REFERENCE:	TSB: 18-007-24 GROUP: 18 - Vehicle Performance	Date:	January 25, 2024	REVISION:	18-056-22 REV. A
VEHICLES AFFECTED:	2019 (DD) RAM 3500 Cab Chassis 2019 (DP) RAM 4500/5500 Cab Chassis This bulletin applies to vehicles equipped with a 6.7L I6 Cummins Turbo Diesel Engine (Sales Code ETN).			MARKET APPLICABILITY: <input checked="" type="checkbox"/> NA <input type="checkbox"/> MEA <input type="checkbox"/> SA <input type="checkbox"/> IAP <input type="checkbox"/> EE <input type="checkbox"/> CH	
CUSTOMER SYMPTOM:	<p>Customers may experience a Malfunction Indicator Lamp (MIL) illumination. Upon further investigation the technician may find one or more of the following Diagnostic Trouble Codes (DTCs) have been set:</p> <ul style="list-style-type: none"> ● P0506-00 - Idle Control System RPM - Lower Than Expected. ● P0607-00 - ECU Internal Performance. ● P20E8-00 - Reductant Pressure Too Low. ● P0301-00 - Cylinder 1 Misfire. ● P0302-00 - Cylinder 2 Misfire. ● P0303-00 - Cylinder 3 Misfire. ● P0304-00 - Cylinder 4 Misfire. ● P0305-00 - Cylinder 5 Misfire. ● P0306-00 - Cylinder 6 Misfire. ● P0299-00 - Turbocharger Underboost. ● P1D73-00 - AGS Performance. ● P0626 - Generator Field Con

Fig. 1

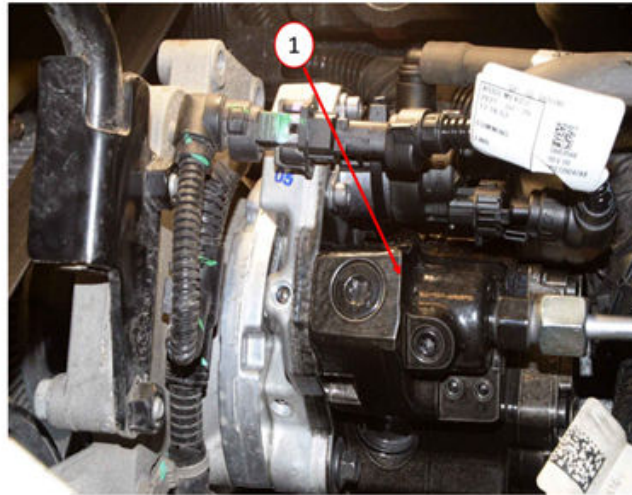
NOTE: The only calibration available will be for the updated CP3.3 design high-pressure fuel injection pump **Fig. 1**. Please ensure that recall Y78 has been completed first before proceeding with this update.

1. Inspect the high-pressure fuel injection pump **Fig. 1** to verify which pump is currently installed on the vehicle. **Also review the vehicle VIP report to see if campaign Y78 has been performed.**

2. Does the VIP report indicate that Y78 has been performed and is the vehicle equipped with the new design fuel injection pump released under the campaign?
 - YES >>> Proceed to [Step 3](#).
 - NO >>> **Perform the Y78 campaign first.** Once the campaign is performed, new pump installed and PCM updated, the PCM will have all of the updates listed in this document. **This Bulletin does not apply.**
3. Reprogram the PCM/ECM with the latest software. Detailed instructions for flashing control modules using the wiTECH Diagnostic Application are available by selecting the application's "HELP" tab.
4. Clear any DTCs that may have been set in any modules due to reprogramming. The wiTECH application will automatically present all DTCs after the flash and allow them to be cleared.
5. Using wiTECH, perform the "Oil Life Restore" procedure located in the ECM "Misc Functions".
